Sydney Football Stadium

Stage 2 Development Application (SSD9835) Design Integrity Assessment Report

Date: September 2019
Author: Infrastructure NSW
Revision: 4

Figure 2: Proposed Landscape Design (August 2019)

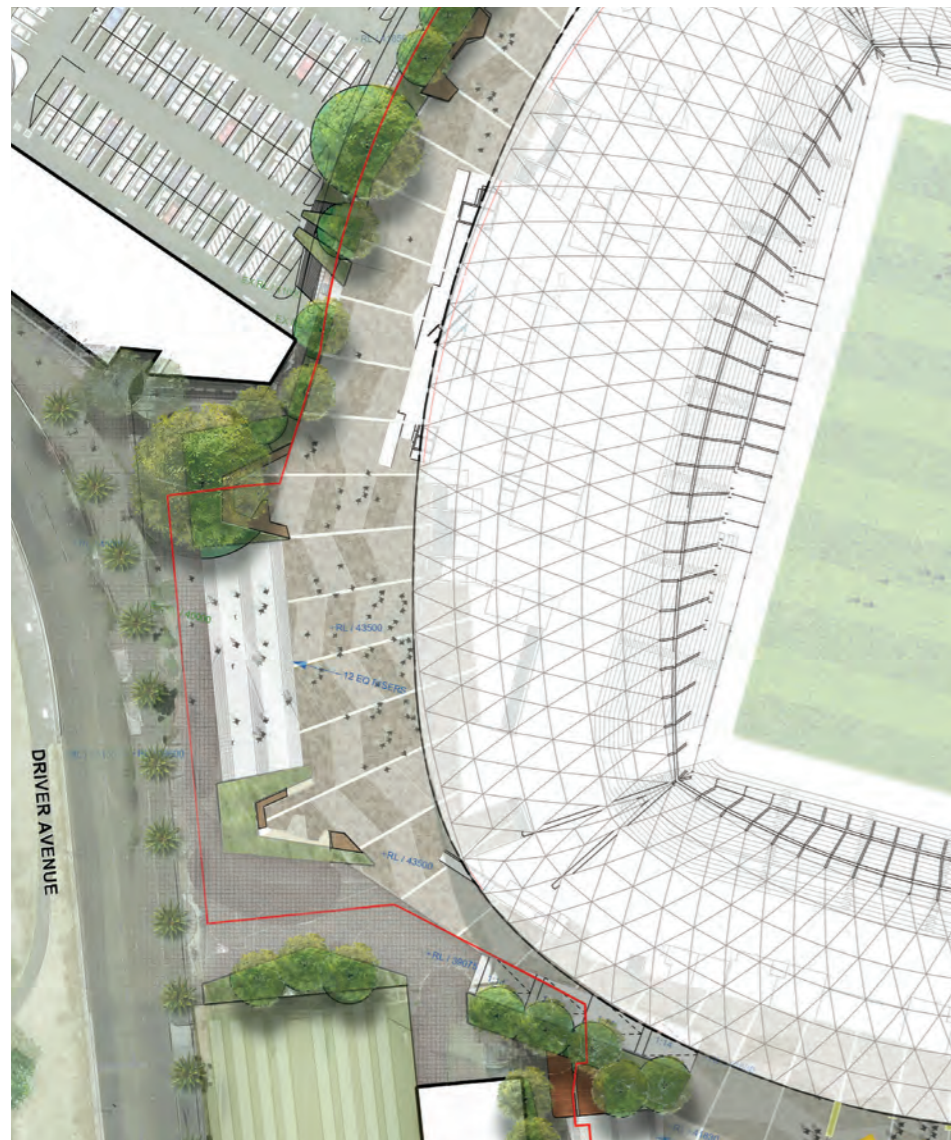
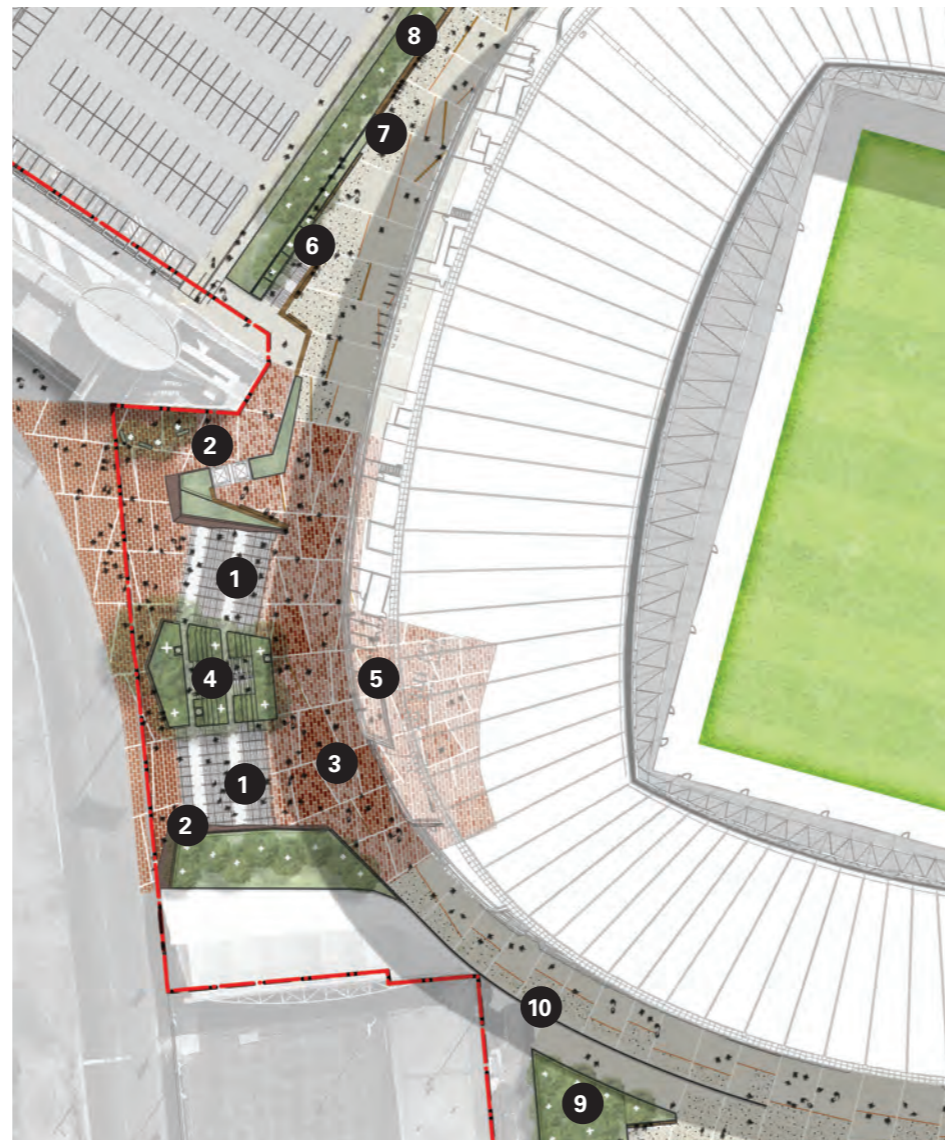
Design Changes (August 2019 changes *italicised*)

1. Split Movement Paths into 2 streams
 - Stairs have been orientated to respond to desire lines
 - 3 flights of stairs respond better to human scale
 - 2 glass lifts added at the north end to provide enhanced accessibility across the precinct

2. Folding Brick stair abutments
 - Create a site Gateway which references the language of gateways in the precinct
 - Responds to Driver Avenue materiality

- Planting at upper level will cascade down walls
 - *Proposed tree planting between abutment wall and NRL building adjusted to avoid diverted Sydney Water infrastructure*

- *Additional planting proposed within concourse*
3. Removal of the Oculus
 - Removal accommodates additional public realm and an entrance arrival more appropriate to the parkland setting

4. Establish central landscaped area with seating terraces
 - Provides for amenity and views over Moore Park and Kippax Lake
 - Forms a secondary movement path

- *Central landscape space in Driver Avenue stair reduced in width and rationalised*
5. Detailed paving to mark site and Stadium entry
6. *Stair width rationalised*

7. *Western edge of concourse reduced. Removal of planted edge and trees at concourse edge to ensure pedestrian flows are accommodated.*
8. *Mass planting with trees proposed on edge of MP1 and stair to MP1 removed*

9. *Layout adjusted to include ramp to members area*
10. *Loss of planting and trees to accommodate pedestrian flows*

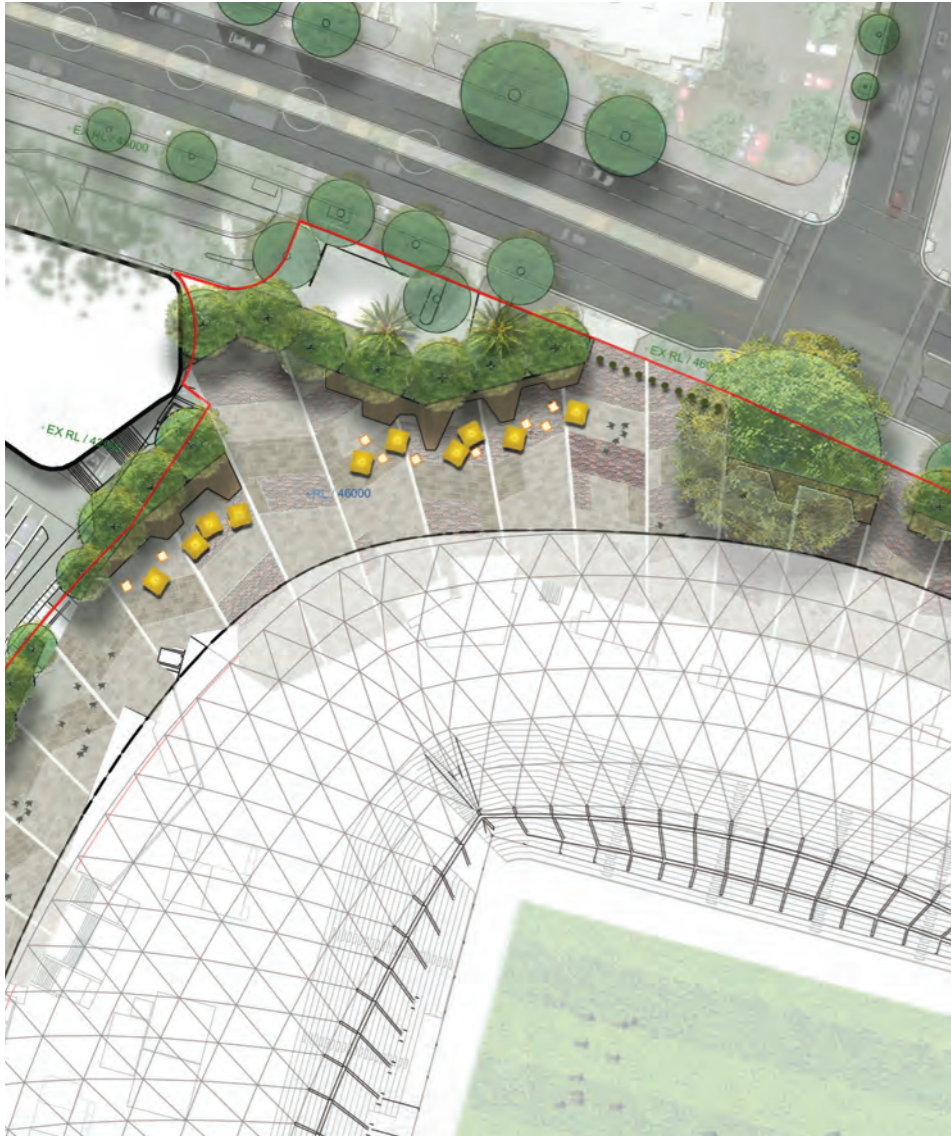
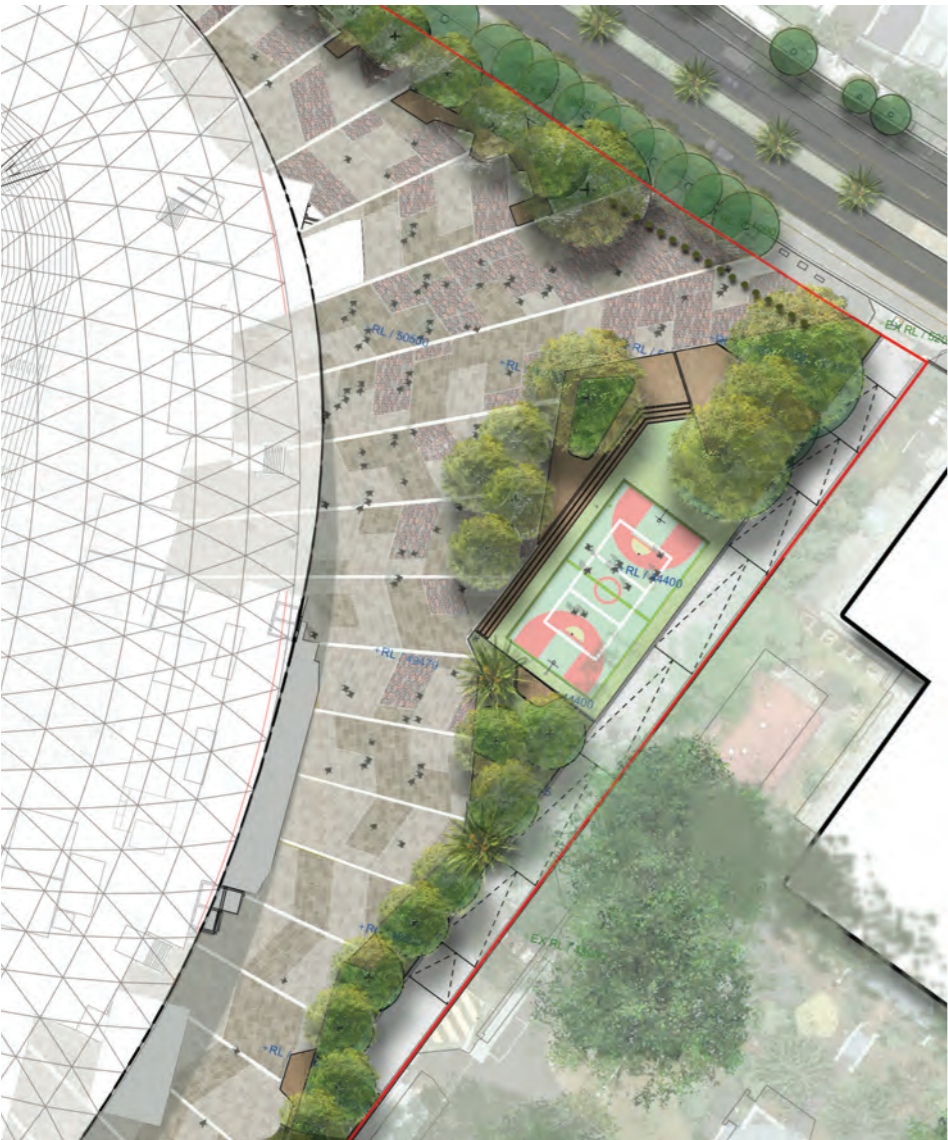
Fig Tree Place		
Competition Concept Design	Proposed Design (August 2019)	Design Changes (August 2019 changes <i>italicised</i>)
		<ol style="list-style-type: none">1. Site extended to include the existing carpark area on Moore Park Road to increase permeability at the north west corner2. Additional trees for passive shade3. The steps adjacent to the Rugby Australia Building moved south. By locating the stairs past the ramp access to the basement, access to the car park is facilitated4. Detailed paving to mark site and Stadium entry5. <i>Geometry and forms of planted landscaped areas rationalised</i>

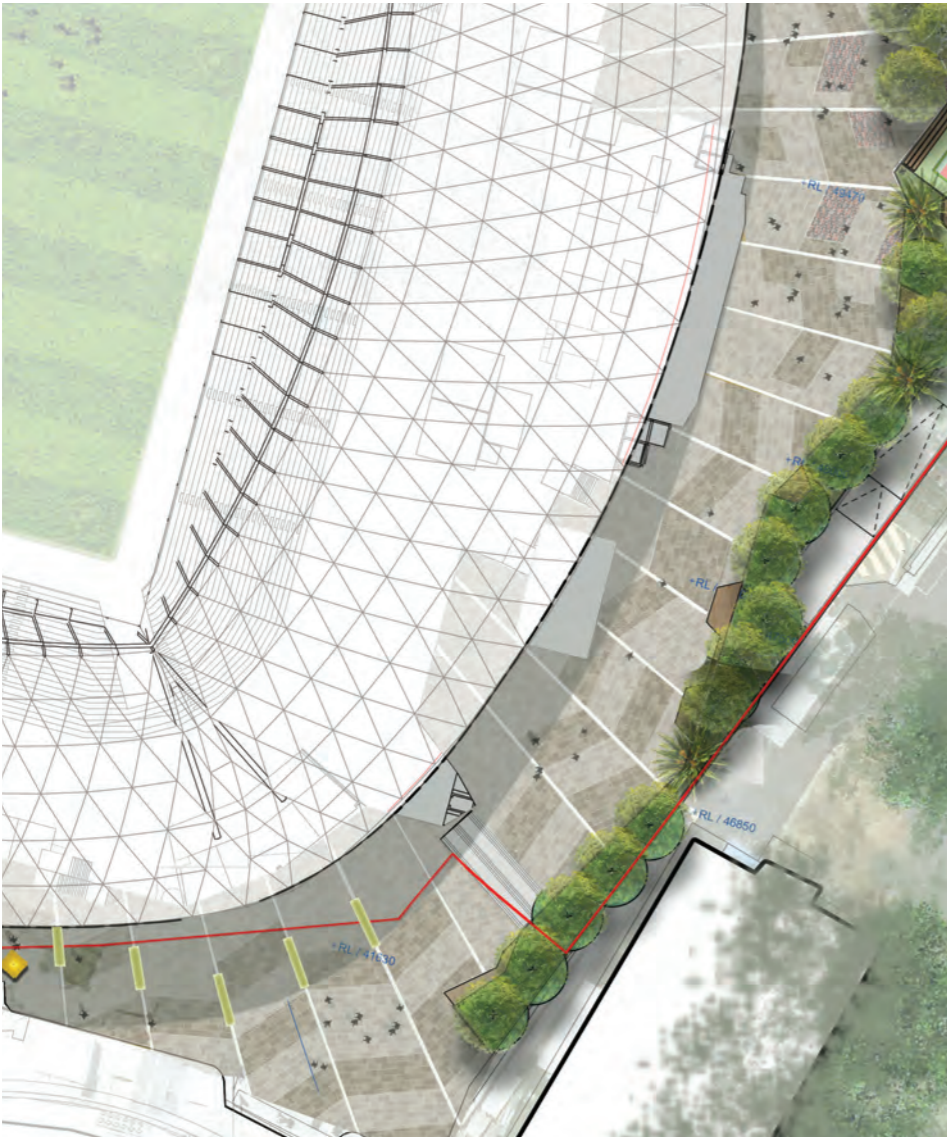
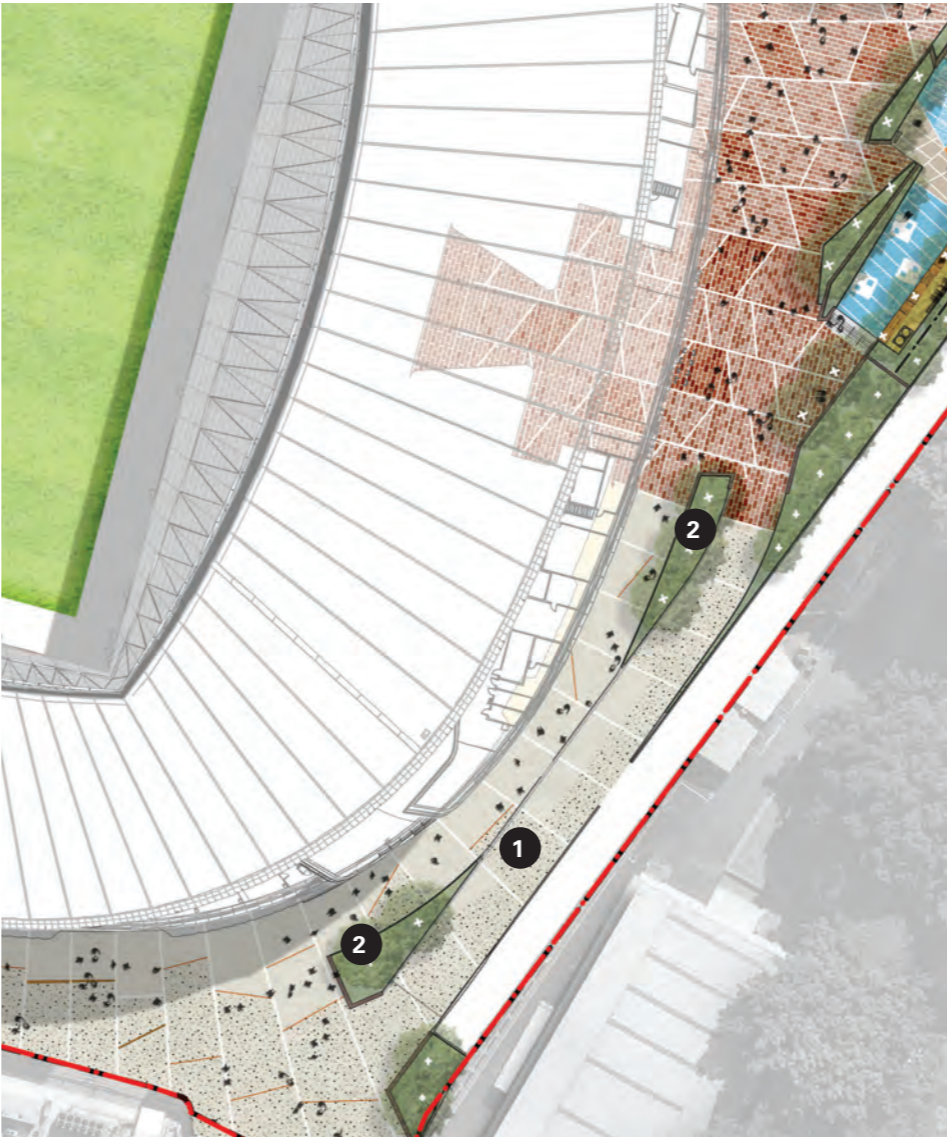
Design Changes (August 2019 changes *italicised*)

1. Stadium Entry moved from north east Corner to Paddington Lane
 - Activity zone restructured to direct pedestrians to stadium entry
 - Structured to allow high volumes of pedestrian egress
2. Arrangement of community area
 - Steps are now on desire line from Moore Park Road
 - Creates stepped activity platforms following concourse grade with flush connections at landings
 - Removal of the full basketball court to be replaced with basketball hoops, exercise provision and informal recreation as a more diverse community offering
 - *Number of stairs reduced to accommodate revised stadium levels*
3. Maintain accessible connection from Moore Park Road
4. Detailed paving to mark site and Stadium entry
5. *Width of stairs adjusted to accommodate pedestrian flows*

South East Corner		
Competition Concept Design	Proposed Design (August 2019)	Design Changes (August 2019 changes <i>italicised</i>)
		<div>1. Removal of southern stairs on Paddington Lane resulting in 'ramped concourse'<ul style="list-style-type: none">- 1:21 from Moore Park Road to stadium entry- 1:14 from Stadium Entry to SCG</div> <div>2. <i>Additional planting proposed</i></div>

Figure 4: Proposed design

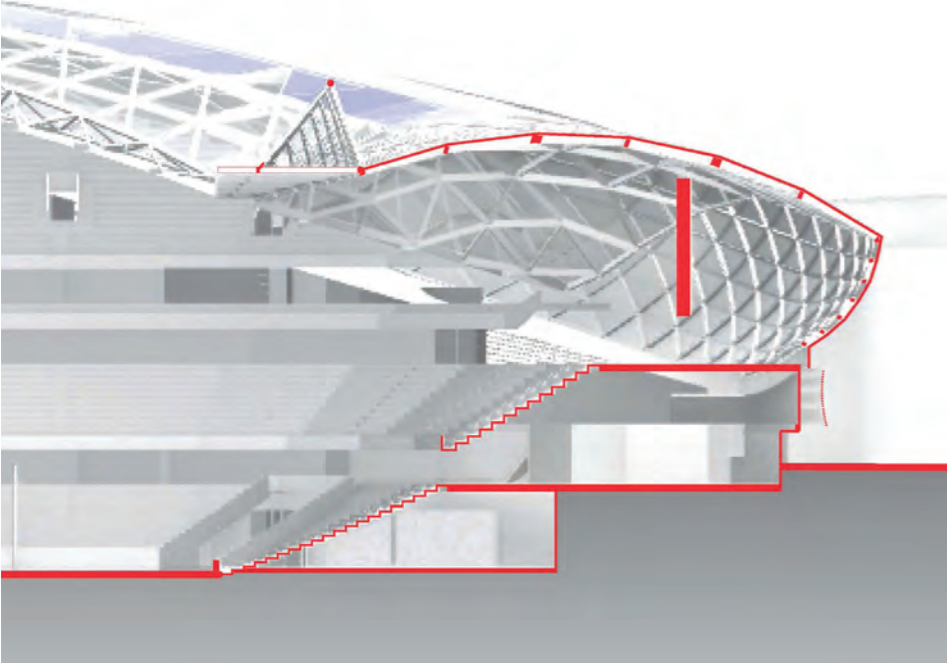
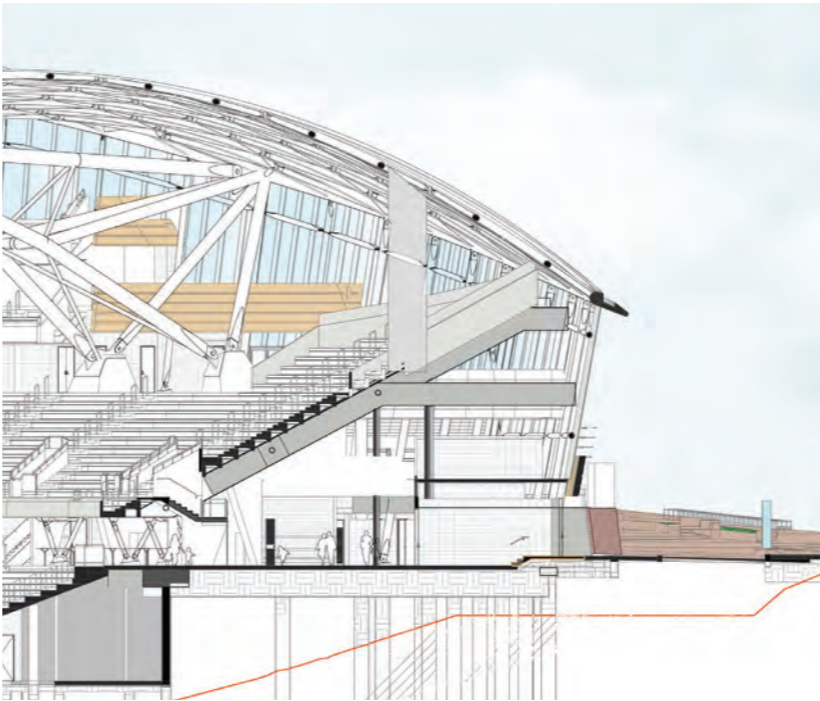
Solar Photovoltaic Array		
Competition Concept Design	Proposed Design (August 2019)	Design Changes
		Distribution of the photovoltaic array modified to better integrate with roof design and provide for more efficient operation.

Roof Line		
Competition Concept Design	Proposed Design (August 2019)	Design Changes (August 2019 changes <i>italicised</i>)
		<p>Roof height at northern and southern ends lowered approximately 1-2 metres to assist in reducing scale of the building.</p> <p><i>Roof height at northern and southern end reduced approximately 5.5 meters from competition winning scheme to reduce scale of the Stadium.</i></p>

Competition Concept Design	Proposed Design (August 2019)	Design Changes
		<p>Removal of landscape from the terraces to the east and west on levels 2, 3, and 4.</p> <p>Removal of level 5 occupiable terraces. Building plant only.</p>

Competition Concept Design	Proposed Design (August 2019)	Design Changes
		<p>Simplification of louvred screen around the Stadium and change of colour to a bronze metallic finish to better integrate with the surrounds.</p>

Reduction of Extent of ETFE

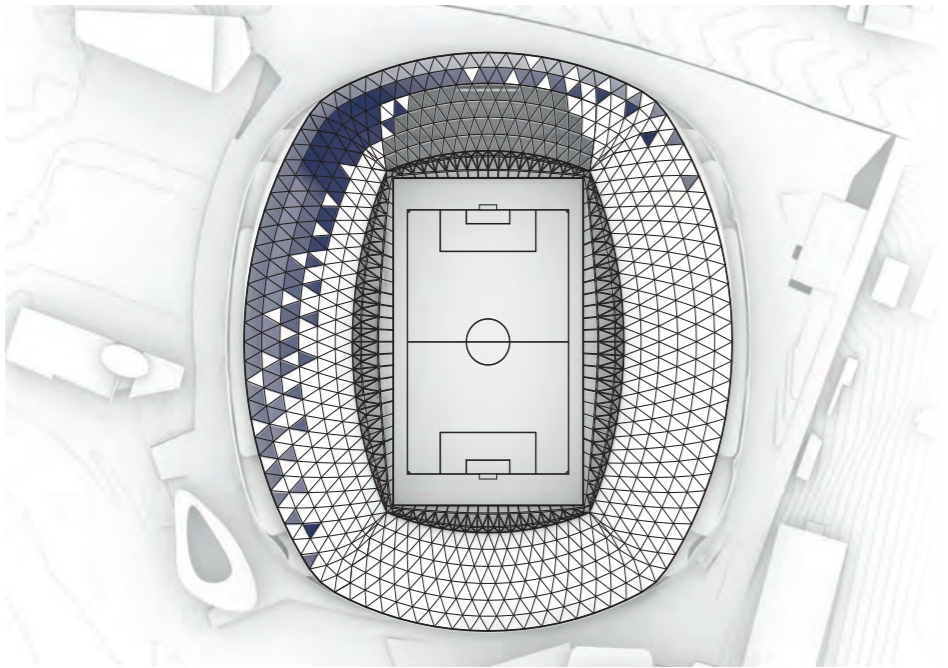
Reduction of Overall Roof Area	
<p>Proposed Design (August 2019)</p> 	<p>Design Changes (August 2019 changes <i>italicised</i>)</p> <p><i>The current roof design has reduced the overall plan area by 2500sqm since the competition design. With a 5.5m reduction north and south and 3m East and West.</i></p>

In the competition design a zone of clear ETFE existed on the northern side of the stadium intended to maximise daylight penetration to the grass pitch. Through further daylight analysis during the value engineering process it was identified that this zone was providing little overall benefit to the grass growth. As a result, this area was replaced with translucent PTFE. This alteration represents an overall reduction of 3800sqm of ETFE from the competition design to the August 2019 design.

North Eastern Entry

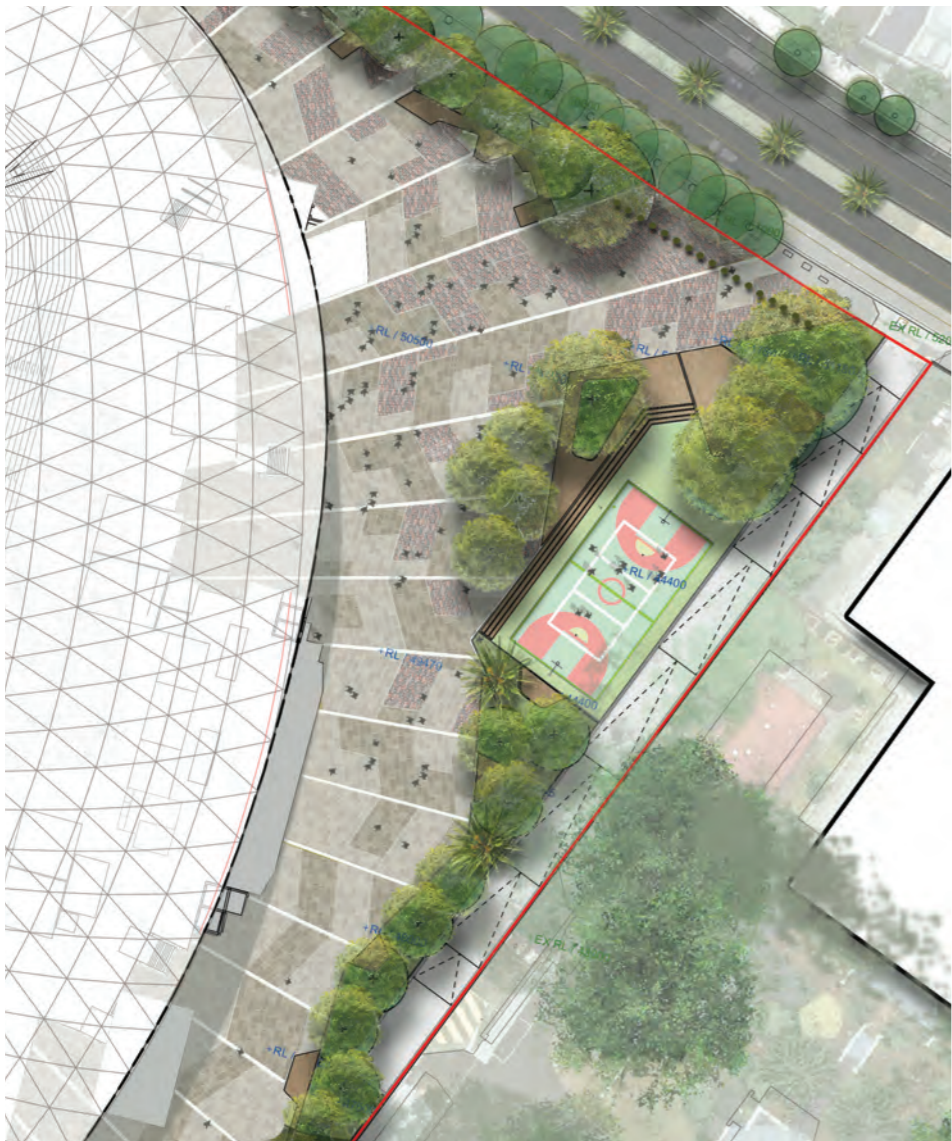
Amalgamation of the north east and south east entries to one entry on the eastern elevation.
